Changes of SPS extraction interlock strategy for TED beam stoppers with LIU beams

Functional specification sent for approval

CERN CH-1211 Geneva 23 Switzerland	EDMS NO. 1839530	REV. 0.1	VALIDITY DRAFT
 	REFERENCE SPS-OTH-ES0001		
Date: 2017-08-25			
Functional Specification			
Changes of SPS extraction interlock strategy for TED beam stoppers with LIU beams			
ABSTRACT:			
<p>FLUKA and ANSYS simulations of LIU beams impacting the TED beam stoppers in the SPS to LHC transfer lines have shown that the stresses reached in some of the TED materials will be beyond the predicted material strength. The intensity on the TEDs with LIU beams therefore has to be limited and the SPS extraction interlocking strategy modified. This document summarizes briefly the simulation results and defines the new interlocking strategy.</p>			
DOCUMENT PREPARED BY:	DOCUMENT TO BE CHECKED BY:	DOCUMENT TO BE APPROVED BY:

Introduction (2)

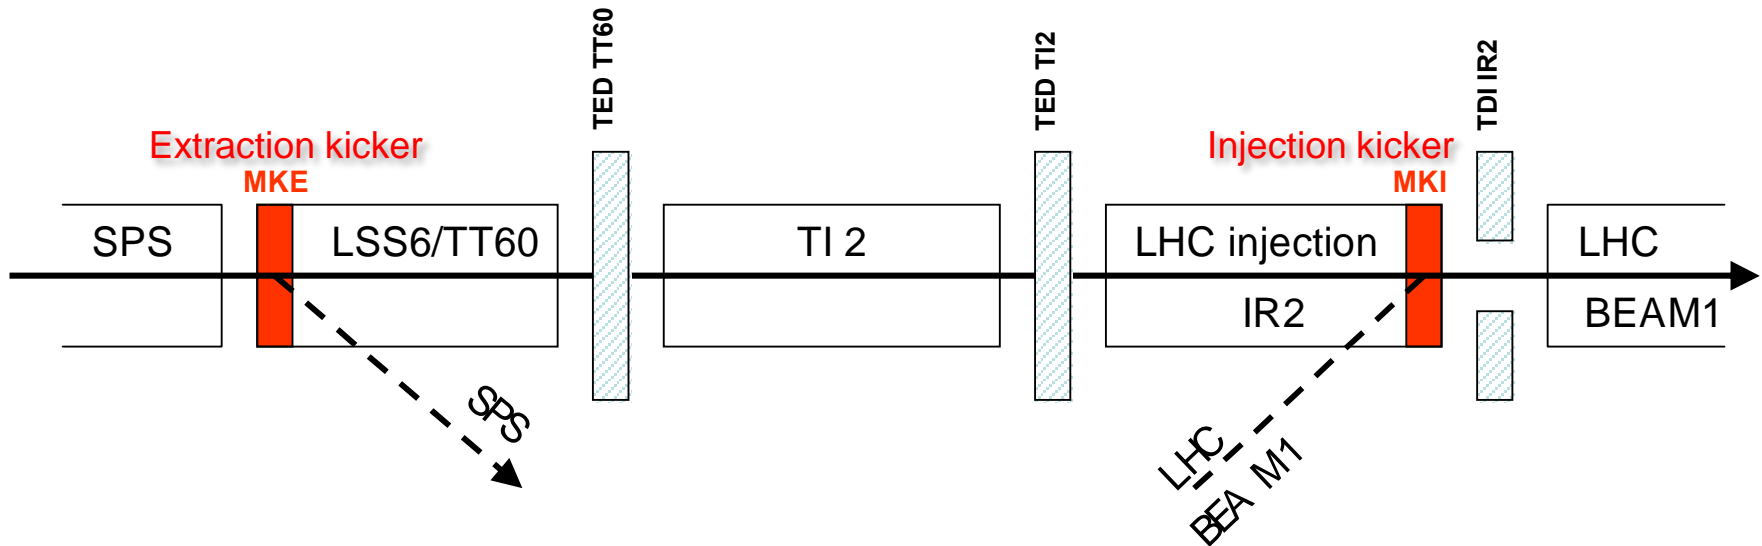
- Interlocking philosophy: If a TED is in beam the interlocks of the downstream equipment are ignored.
- If TEDs are moving, extraction is never permitted. Only if **in** or **out**
- This is true for any intensity to be extracted from the SPS

- The current TED design cannot withstand more than 144 LIU intensity bunches.
 - Graphite goes beyond service stress
- Proposal:
 - Keep current design
 - Limit intensity to max. 144 LIU bunches to be extracted from the SPS with TEDs in the line

- The new flag is taken into account in the user permit of the TEDs, where it is checked whether it is moving or not.
 - The logic will be completed to take into account the SPS_TBF as follows:
User Permit = TRUE when ((TED_IN \cap SPS_TBF=TRUE) \cup TED_OUT)
else User Permit = FALSE
